BIA G1808-RP-01-E4
Supplementary Note G1808-SN-01-E1

Project 31 Willoughby Road NW3 1RT
Subject Response to Campbell Reith Audit D3

Project Ref G1808
Date 02/21

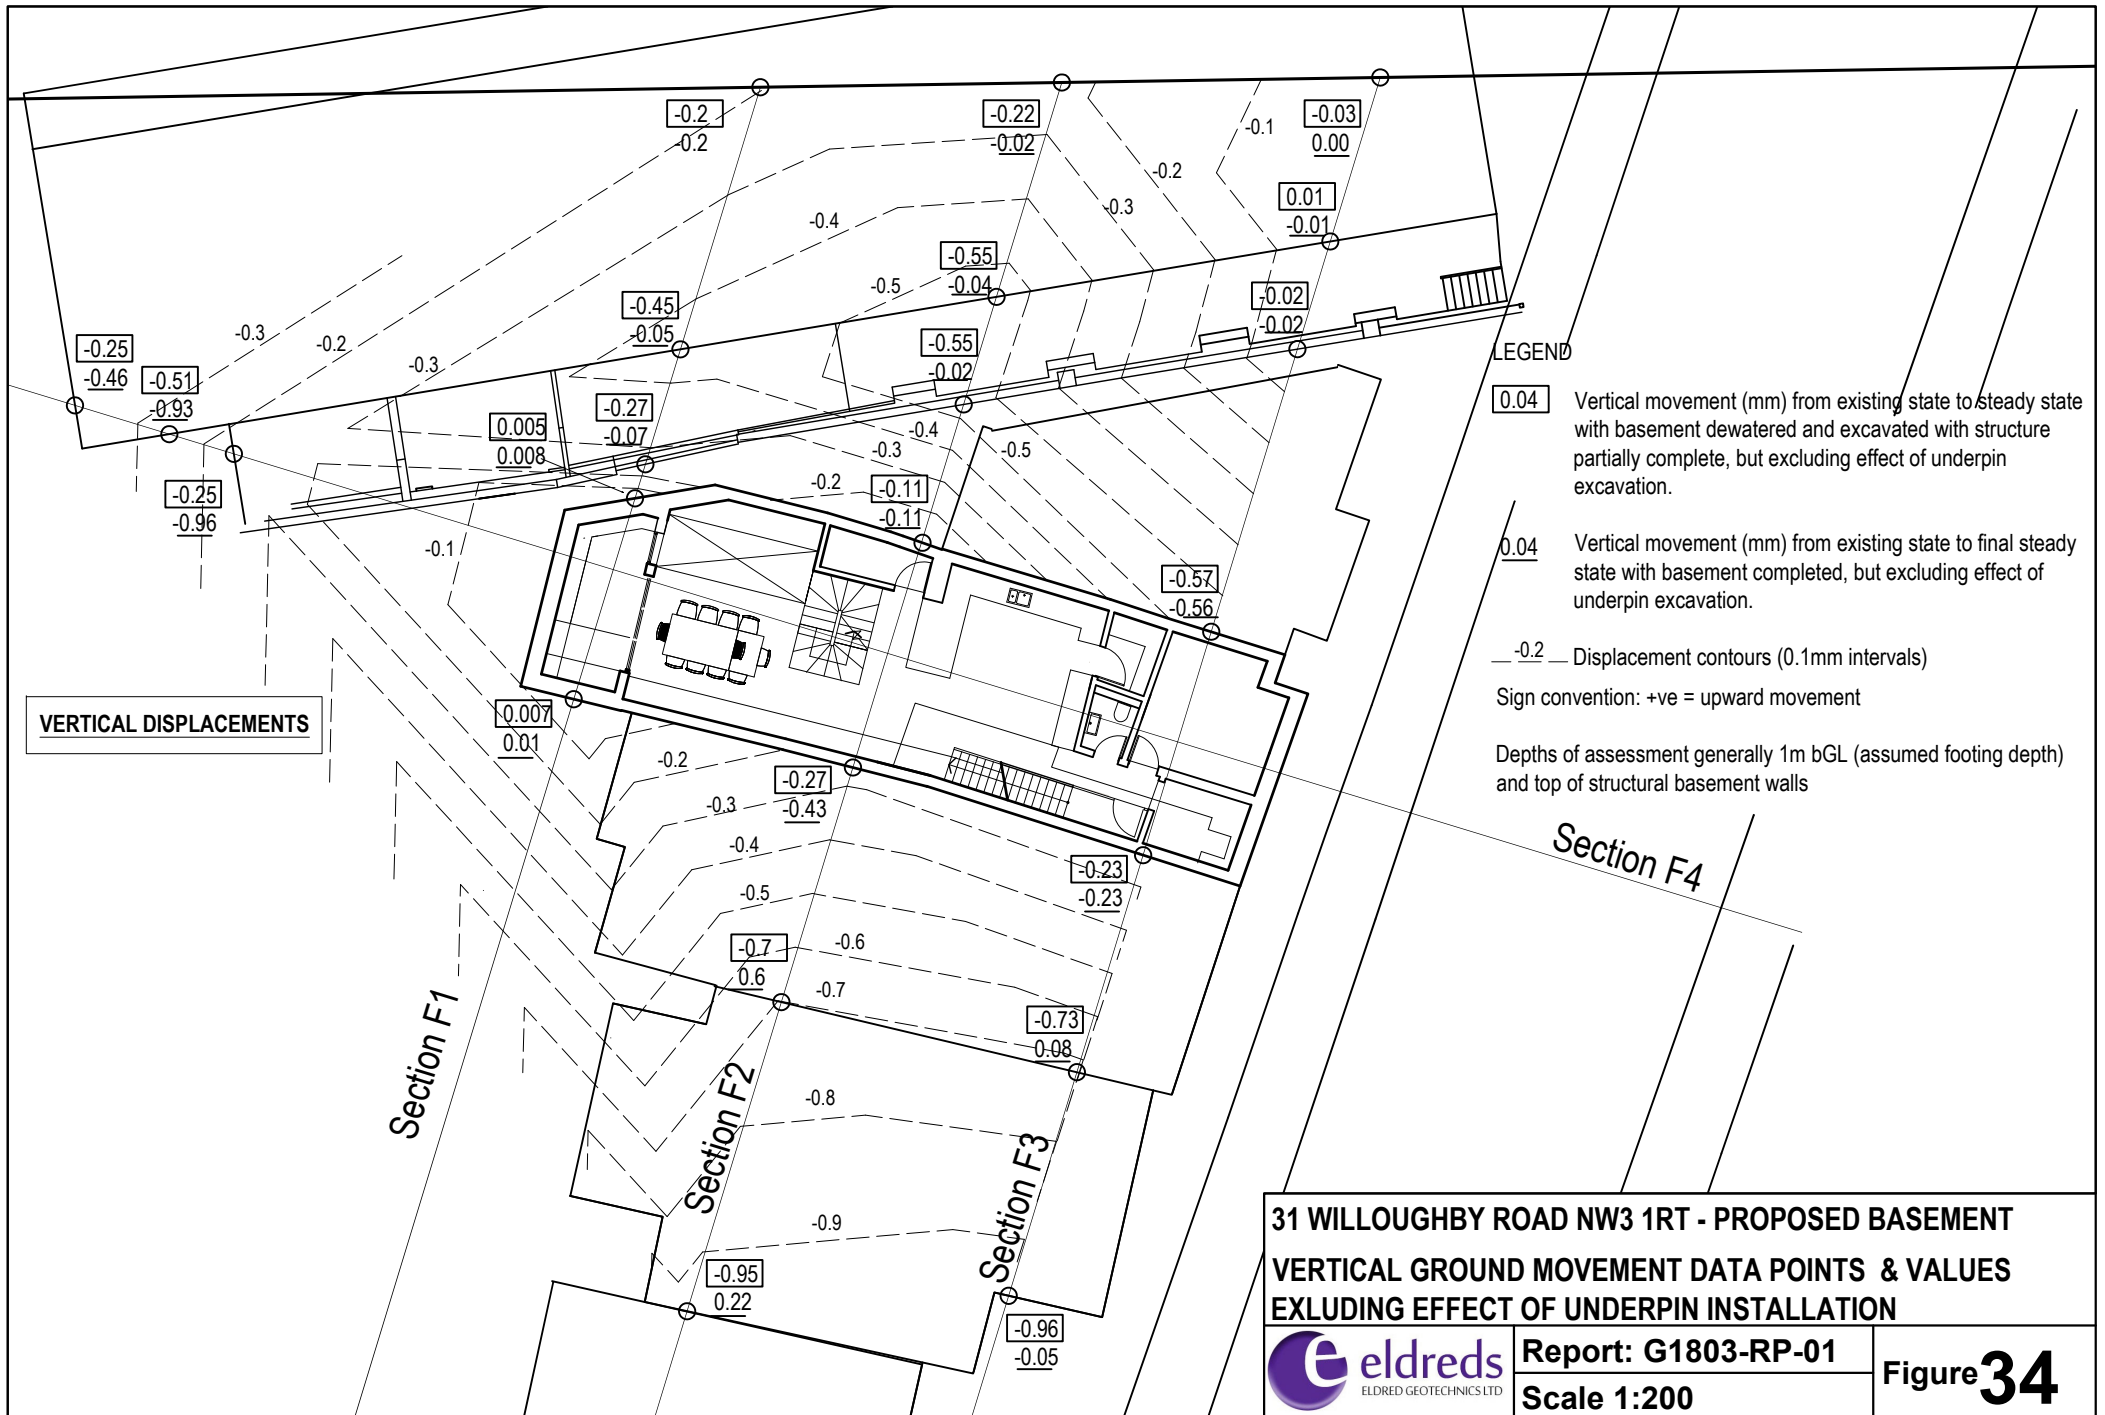
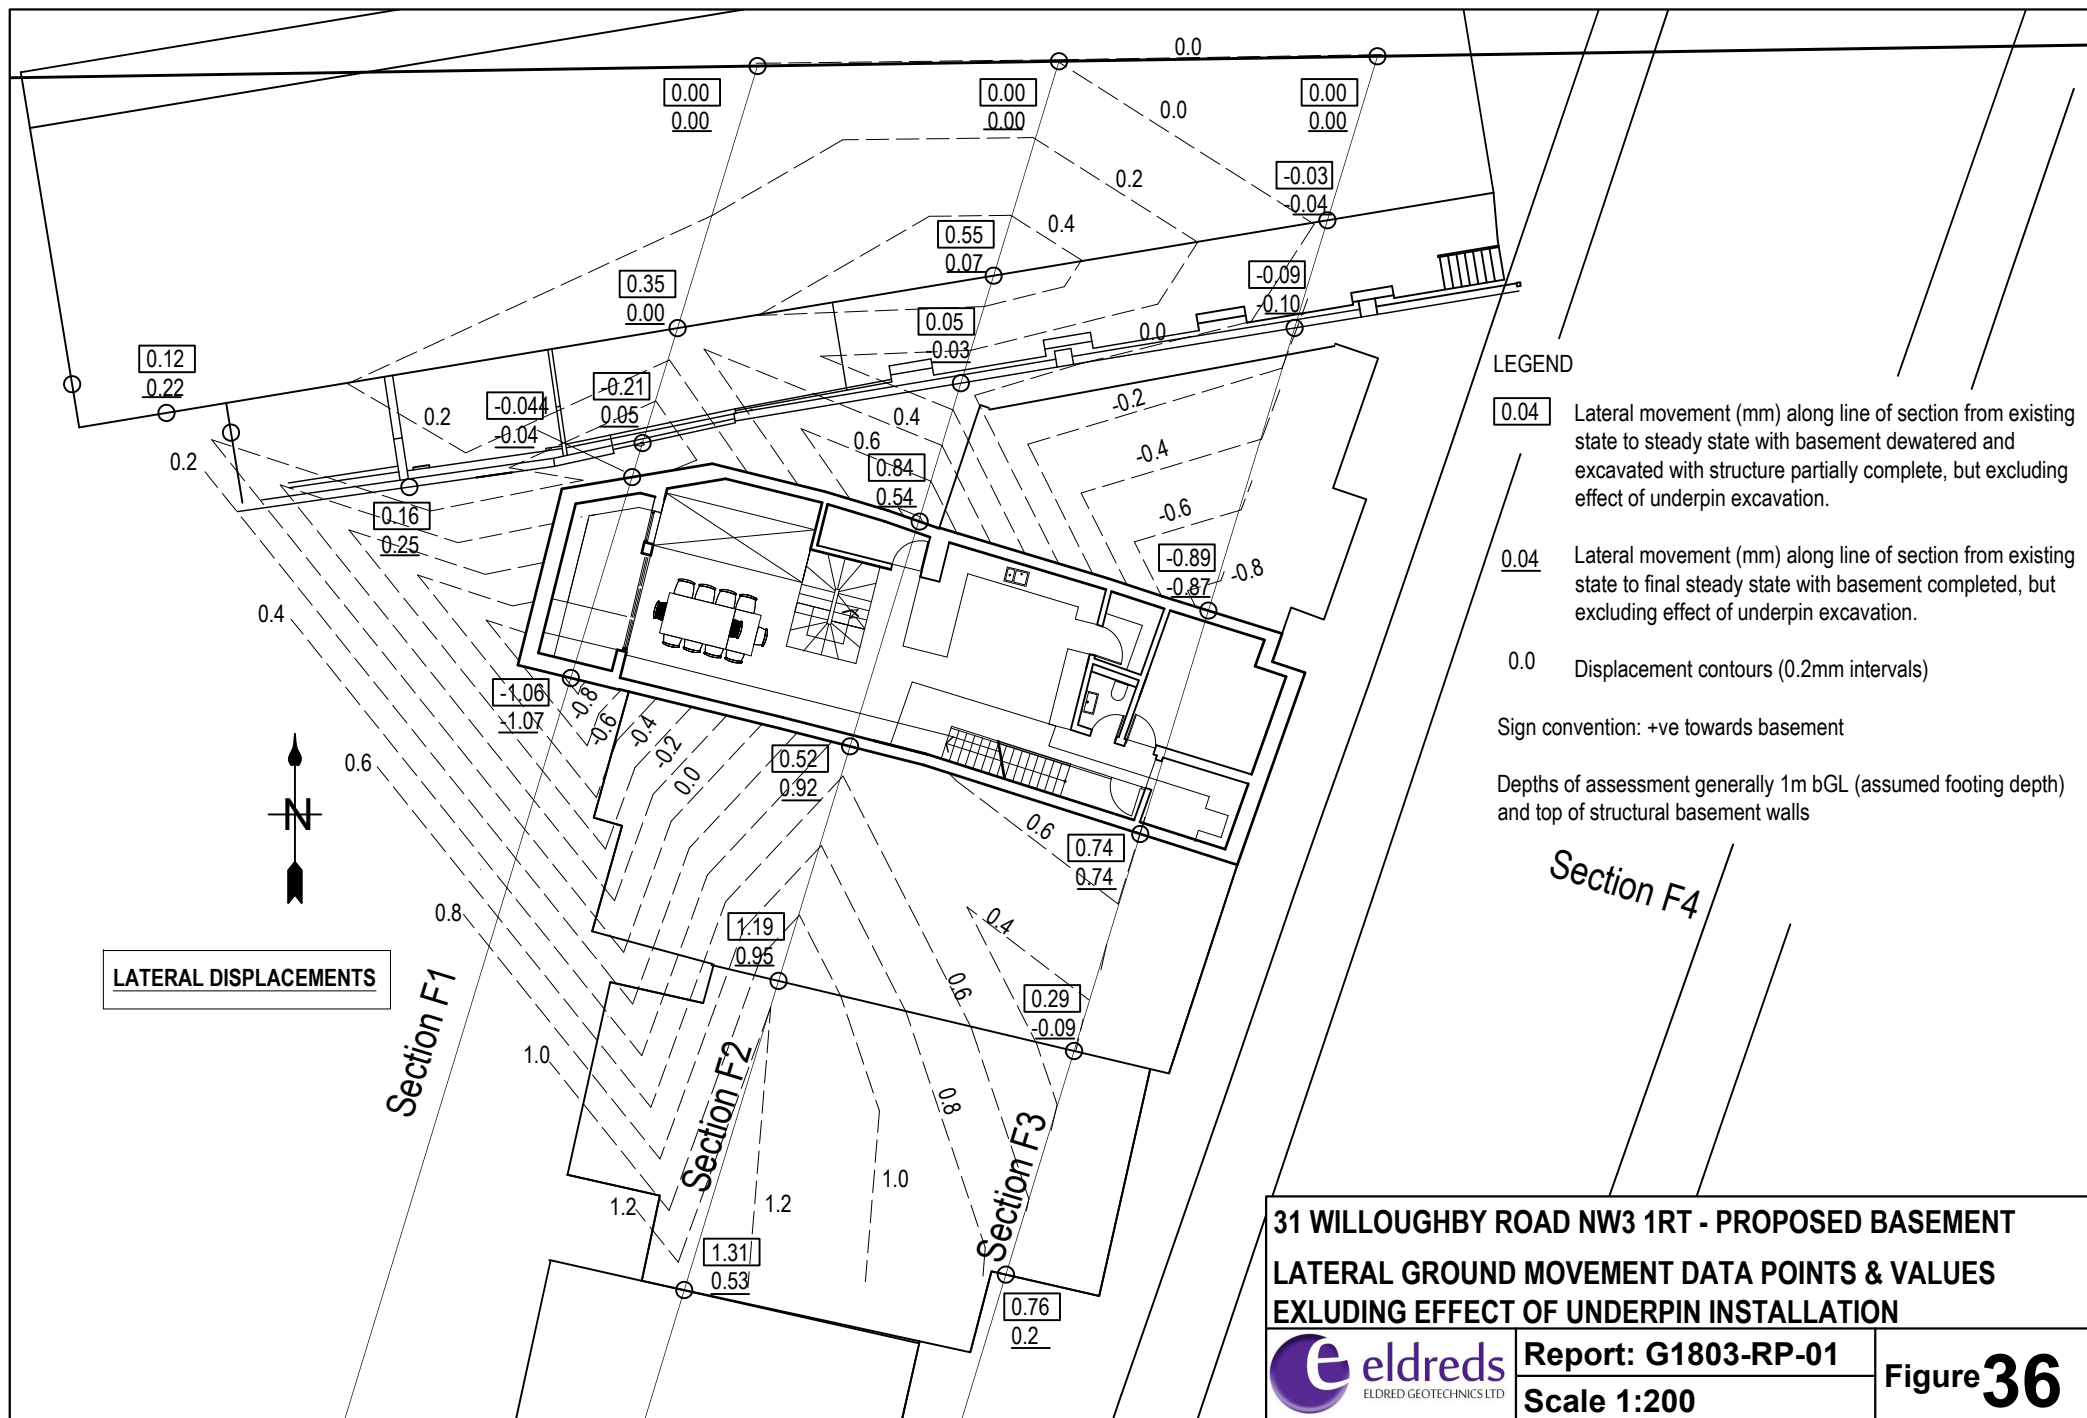
21. The auditor found the presentation of the modelled displacement data and damage risk assessment difficult to follow, was concerned to know if the effect of concrete shrinkage on underpinning had been allowed for and considered that transparency was lacking. A GCG report for the neighbouring residents suggested that the Burland method of assessing damage risk is unsuitable for use in conjunction with Willow Cottages and commented on interpretation of the table of risk classifications attributed to him. GCG also considered that since the Willow Cottages sewer had been assumed to carry the culverted former watercourse, it should be included in the risk assessment.

22. Whilst there has been no concealment of analytical input, method or results in the BIA it is accepted that graphical presentation will greatly improve their ease of assimilation. Referring to appended Figures 34 to 37 and tables:

- (i). The scheme of monitoring illustrated was designed principally to examine the predicted structural displacements from existing condition due to basement excavation, construction, groundwater drawdown and recovery. Footing data points were generally located at 1m below local ground level, lateral wall movements correspond to the tops of walls.

- (ii). Analysed displacements are all very small, typically 0.0 to 1.0mm. Point values and derived contours of vertical movement show the expected influence of draw down and heave. Lateral movements are more complex and on the north side of No.31 are influenced by the topography of existing structures.
